IN THE MATTER OF AN APPLICATION
BY THE REGIONAL MUNICIPALITY OF HALTON
FOR THE CONTINUED USE OF THE
BURLINGTON LANDFILL SITE

Witness Statement

I.R. PAWLOWSKI
Hydrogeologist
Waste Site Evaluation Unit
Waste Management Branch
Ministry of the Environment

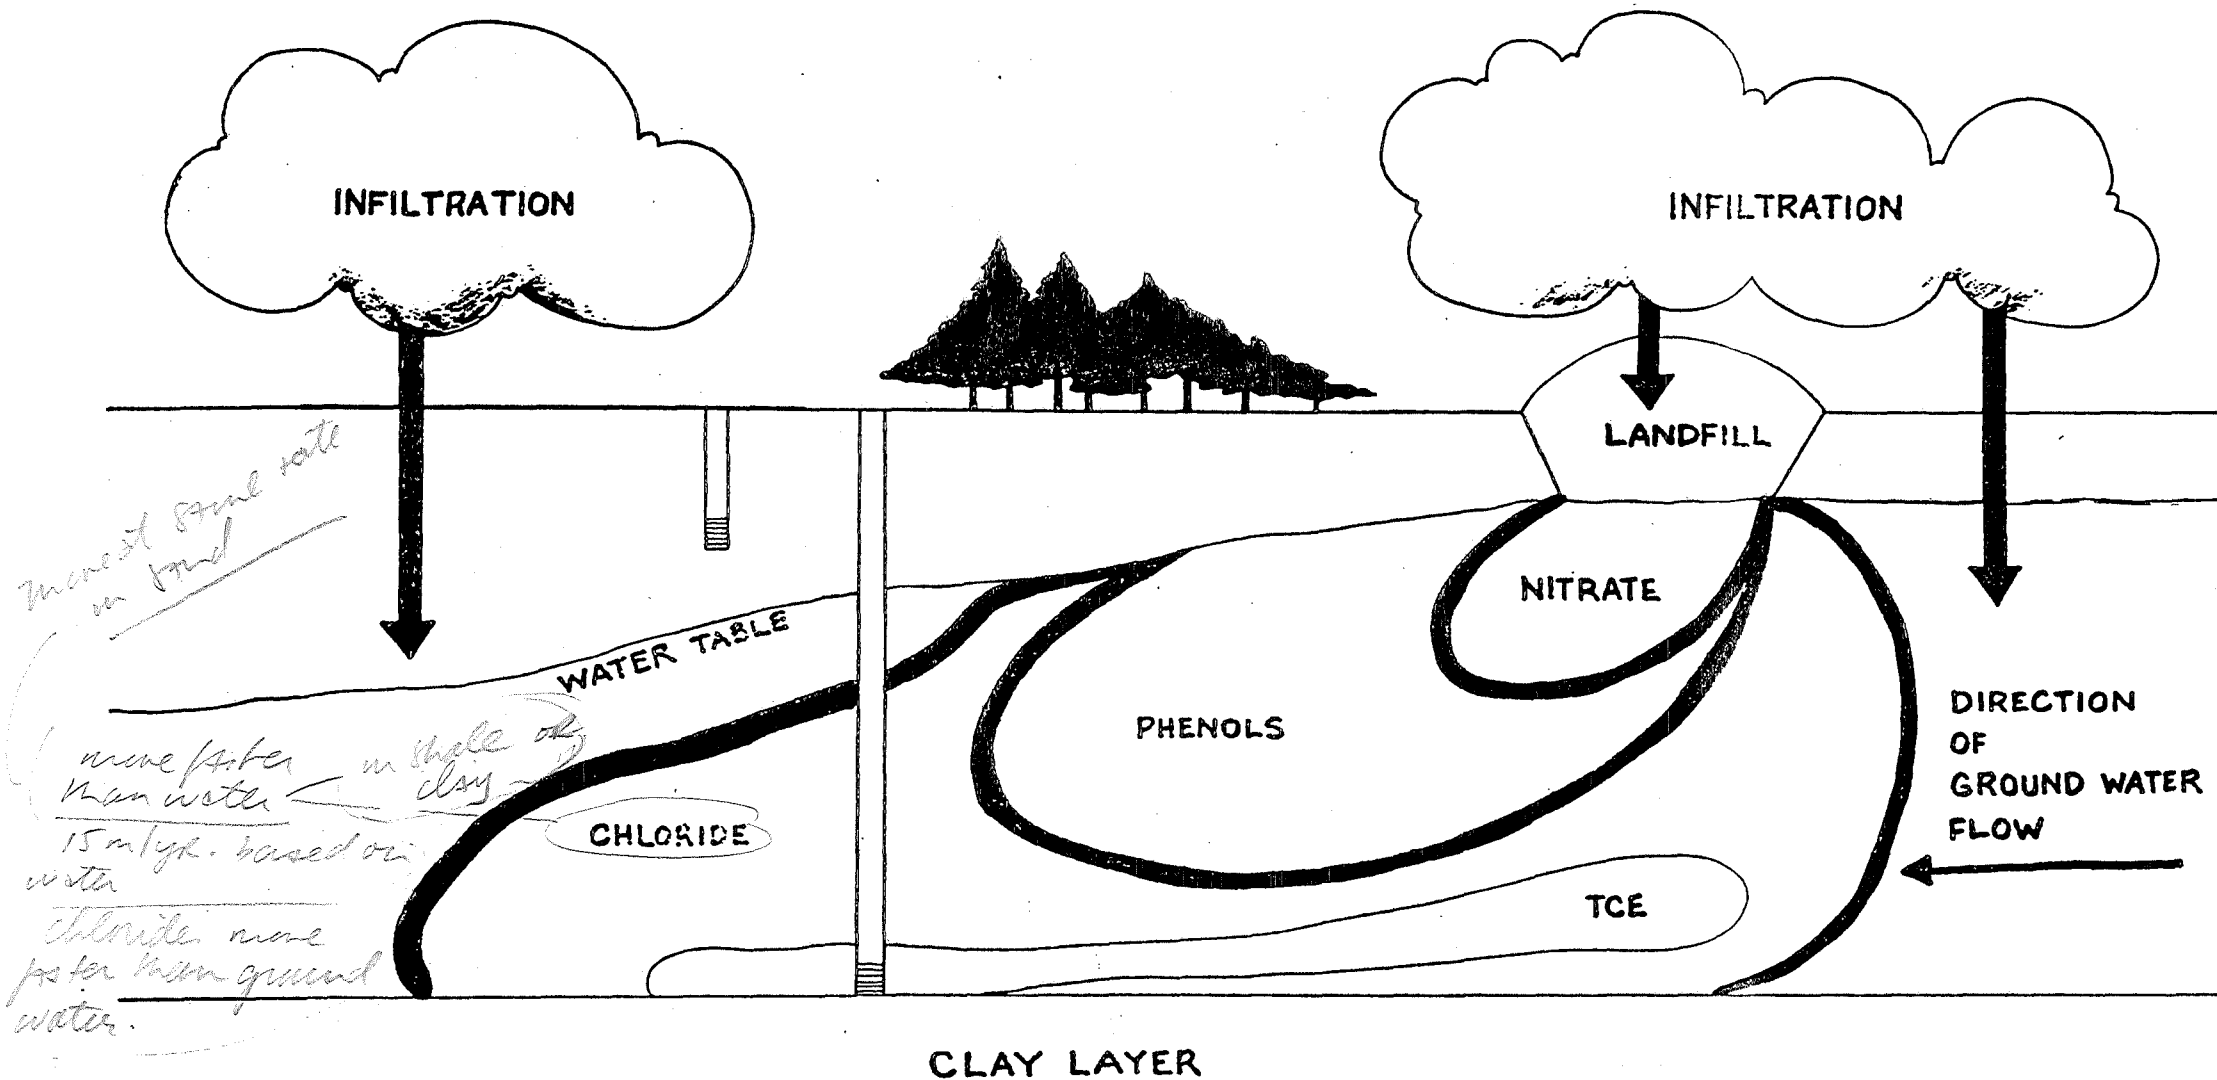
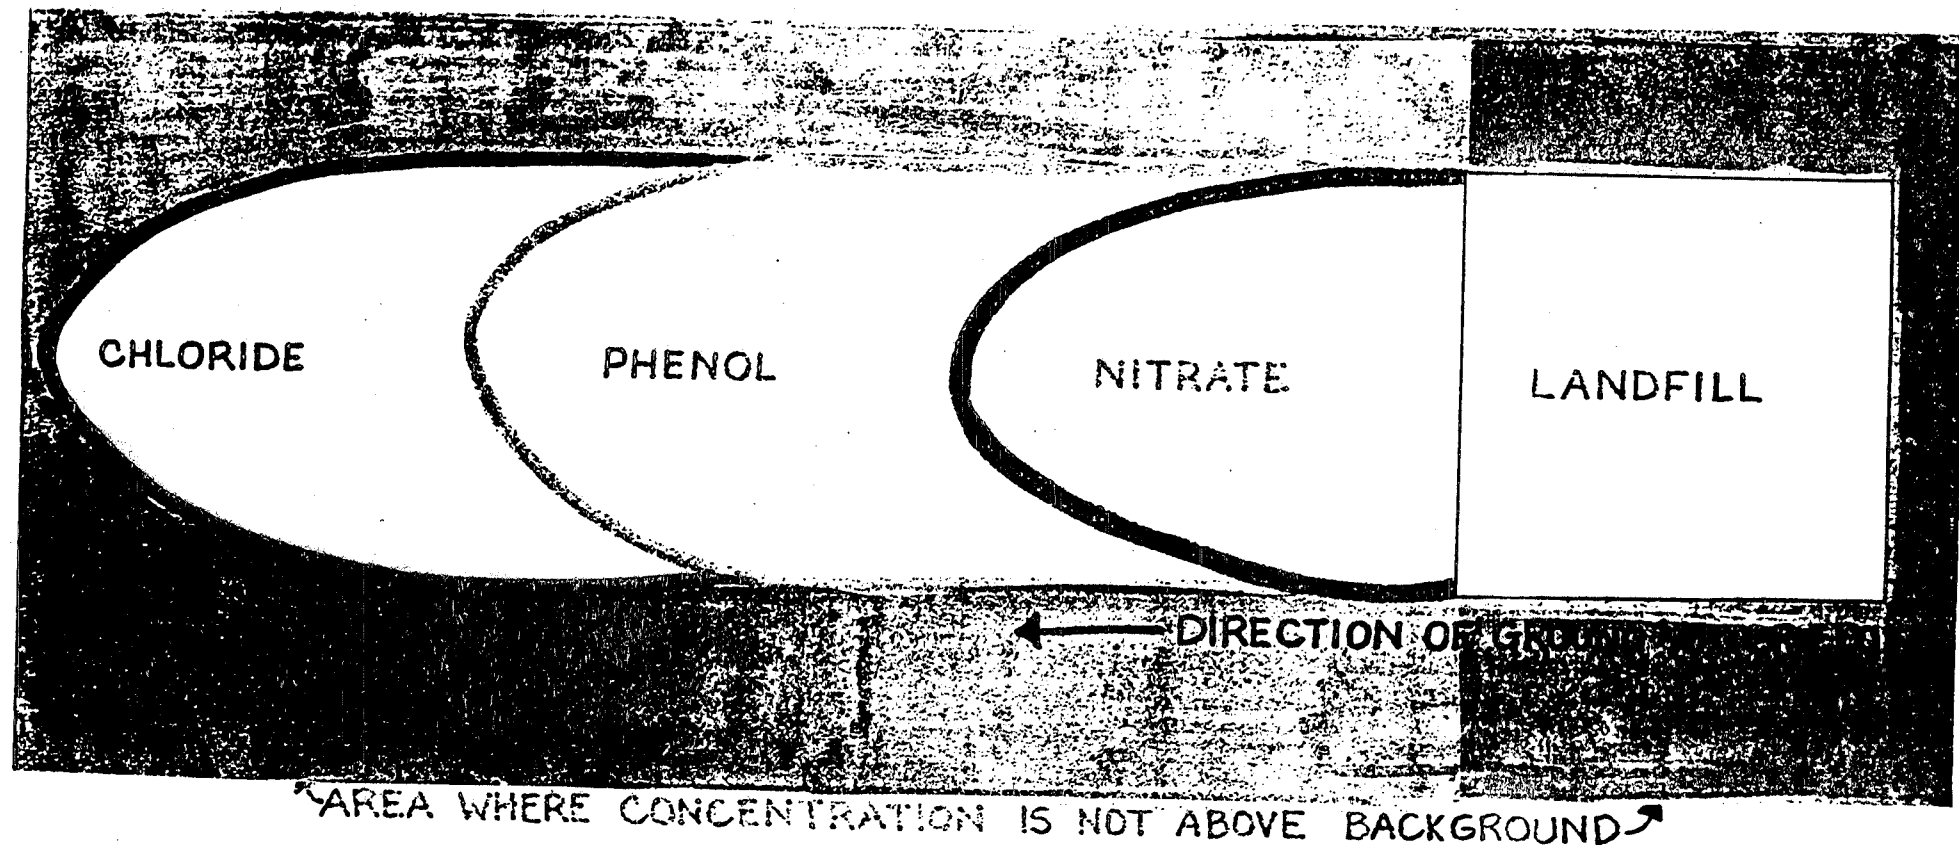
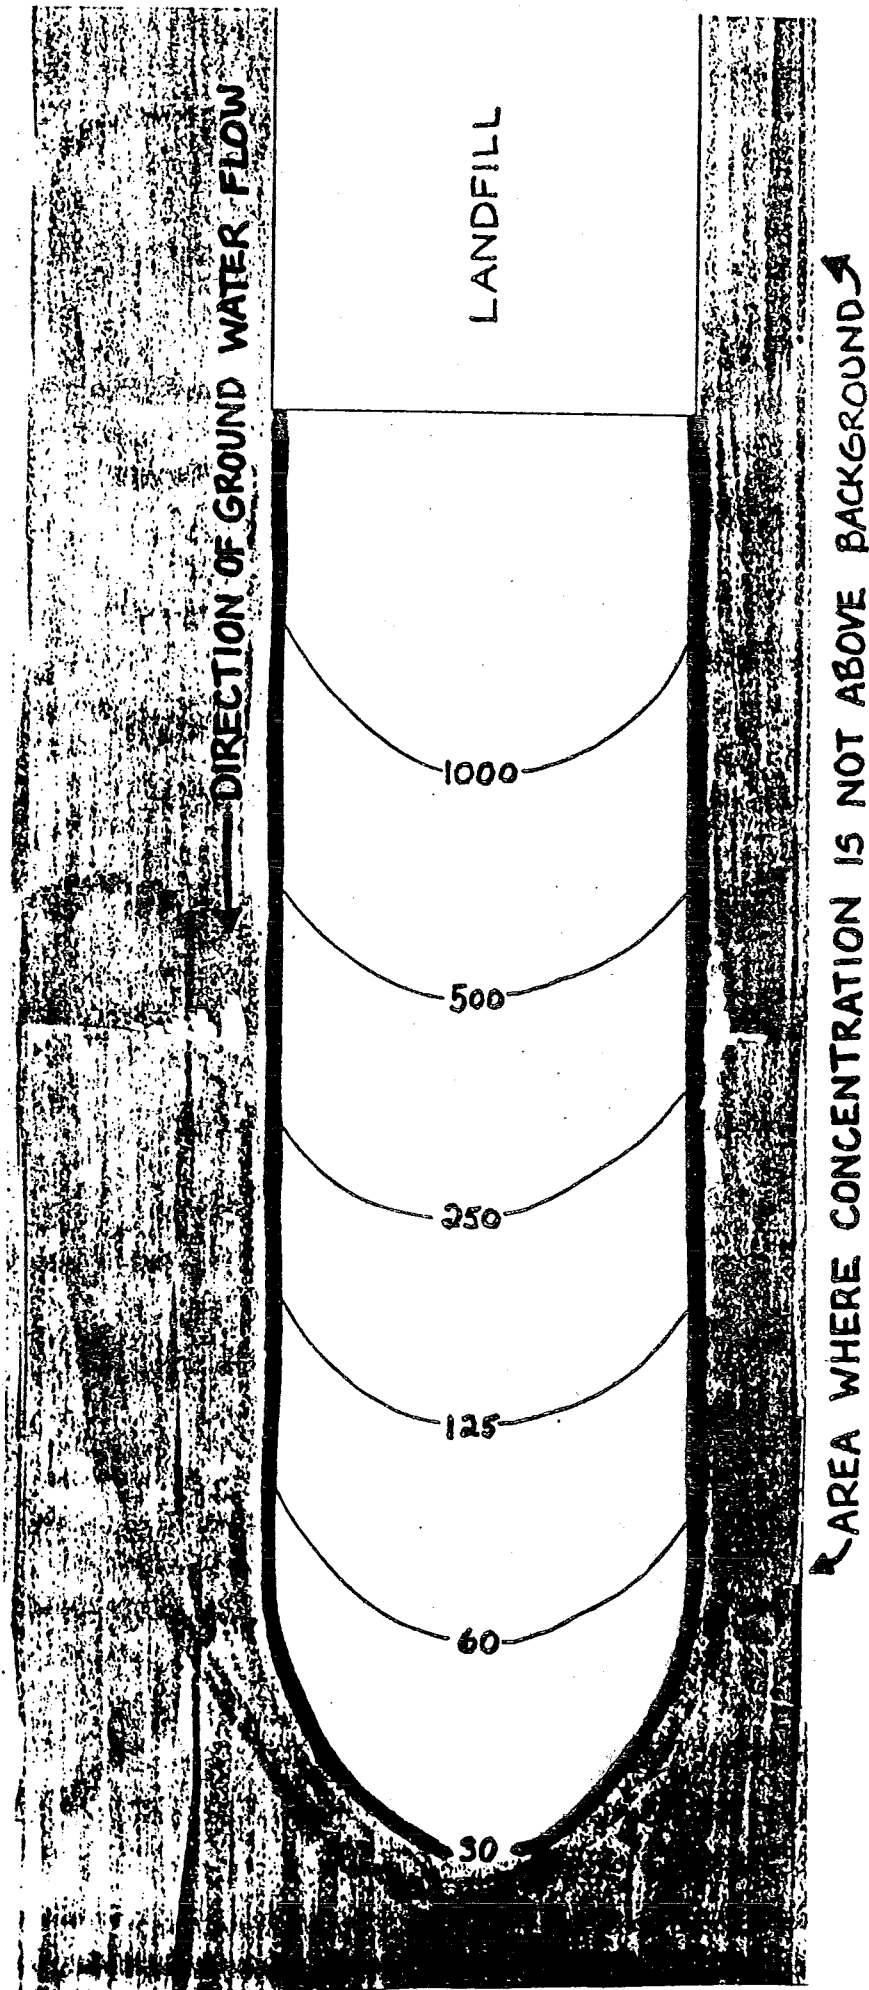
In my opinion, some general information about the movement and attenuation of leachate would be of some assistance. Figures 1, 2 and 3 (attached), illustrate general distributions of various leachate parameters based on existing information from other areas in side view and in plan view.

FIGURE 4

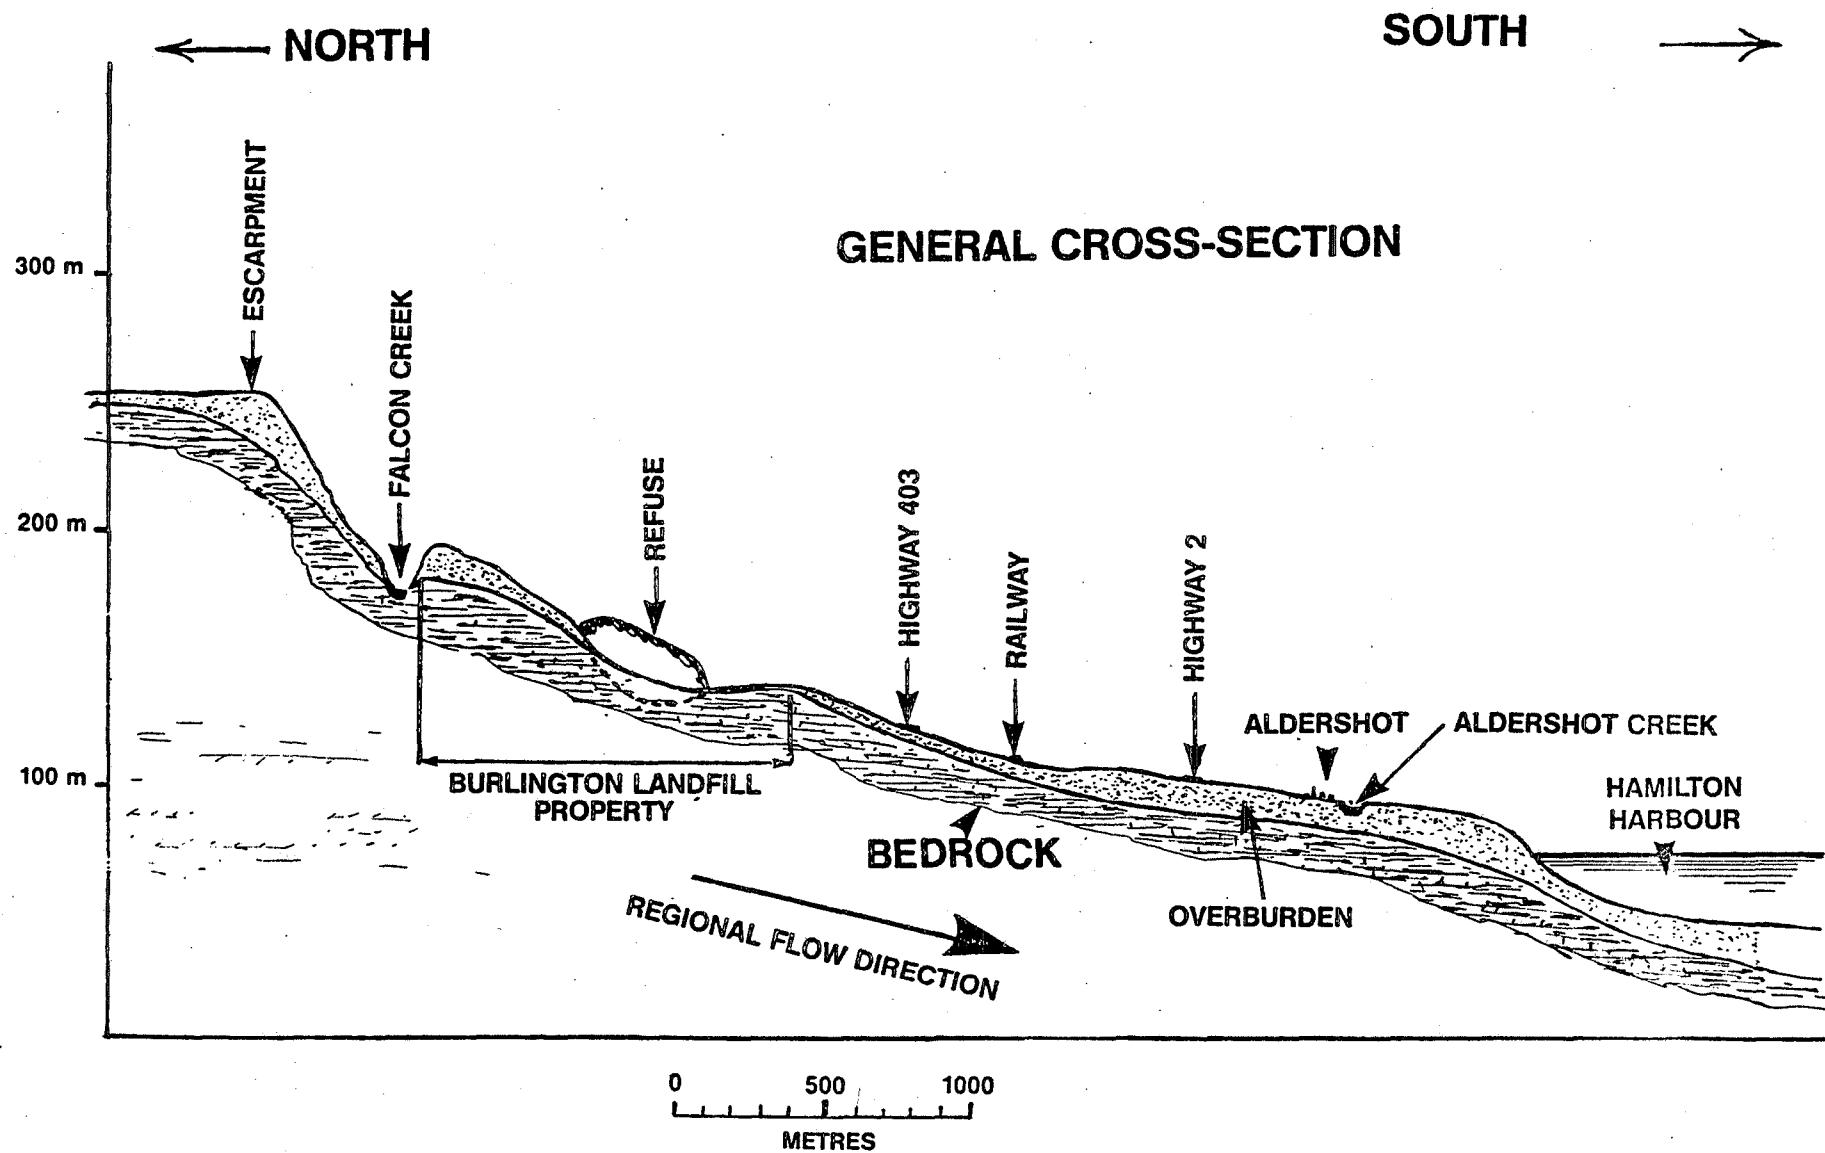
- did about
under creek
we have
upper gradient
sand sediments by
high
immobility
the upper gradient
will be discharge
- (c) Based on available information, shale outcrops have not been mapped in the Aldershot area drained by Falcon Creek. The overburden thickness increases in the direction of Hamilton Harbour. Figure 4 is a representation, in exaggerated vertical scale, of the relationships between the landfill site and Hamilton Harbour and between the overburden and the
- at least - have you checked
the upper gradient
will be discharge*

bedrock. The regional groundwater flow direction is also illustrated.
